STAFF REPORT

SUBJECT: H-2020-0046
Gateway at Ten Mile

LOCATION: The site is located at the northeast corner of N. Ten Mile Road and W. Franklin Road, in the SW ¼ of the SW ¼ of Section 11, Township 3N., Range 1W.

I. PROJECT DESCRIPTION

B. Bubble Plan (date: 6/8/2020) (NOT APPROVED)

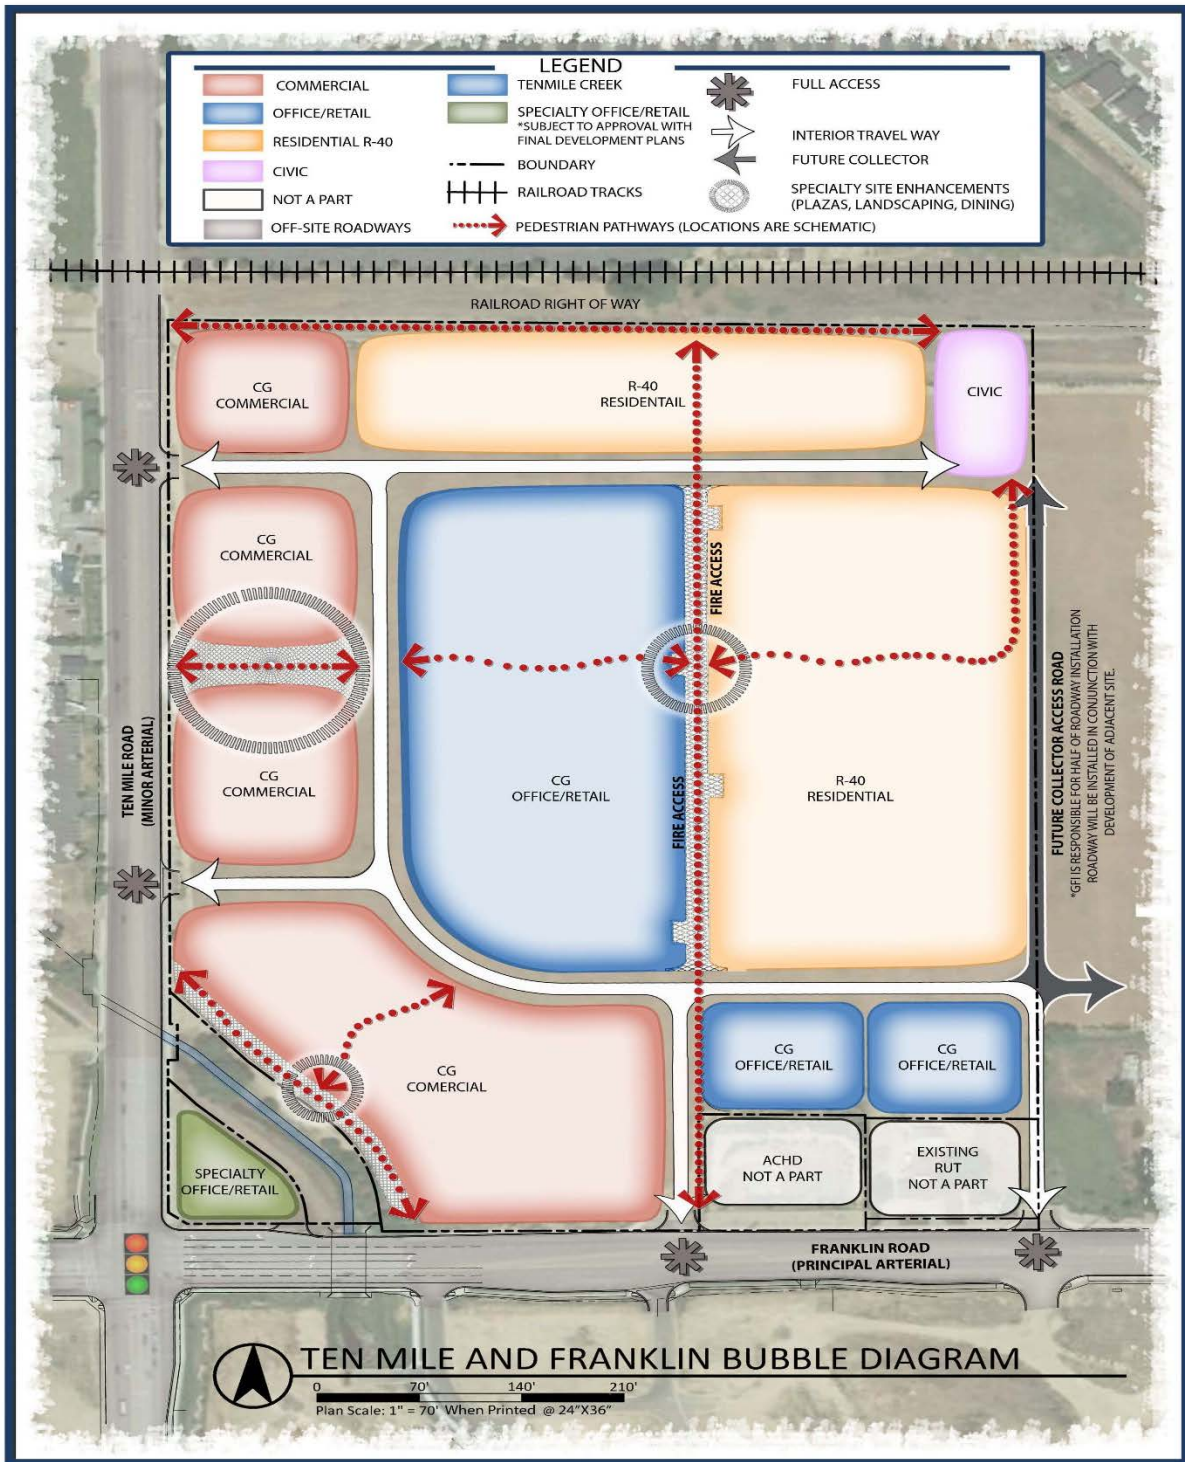
“Avoid the concentration of any one housing type or lot size in any geographical area; provide for diverse housing types throughout the City” (2.01.01G). The proposed bubble plan shows R-40 zoning which is meant for high-density residential. In line with this, the Applicant plans to construct multi-family residential and some 3-story townhomes in the requested R-40 zoning area. In the nearby vicinity of this site there is detached and attached single-family residential and multi-family residential. There is other R-40 zoning in the area where multi-family is under construction, an area where multi-family is already constructed, and another area of R-40 zoning that is zoned but not yet developed. There is also R-8 and R-15 zoning districts nearby that house the single-family residential options for the area. Staff believes that some additional multi-family residential is a good fit for this area and the proposed density of commercial uses, provided there be a mix of housing product types and designed consistent with traditional neighborhood principles.

The proposed uses are not yet set in stone. However, the Applicant’s ~~bubble concept~~ plan depicts multi-family residential; commercial; and office/retail. This application is requesting C-G and R-40 zoning; multi-family residential is a conditional use in the R-40 zoning district per UDC Table 11-2A-2 and the C-G zoning district allows multiple types of commercial, retail, and office uses.

Even though the subject site is used for agricultural purposes and has historically been so, there are multiple curb cuts along W. Franklin Road and N. Ten Mile Road, arterial roadways. The submitted bubble plan shows the Applicant's desire to keep a majority of the existing curb cuts for future access.

- a. ~~The submitted bubble plan in Section VII.B is not approved as shown. At least ten (10) days prior to the City Council hearing, the Applicant shall submit a revised bubble plan reflecting Staff's recommended revisions herein.~~
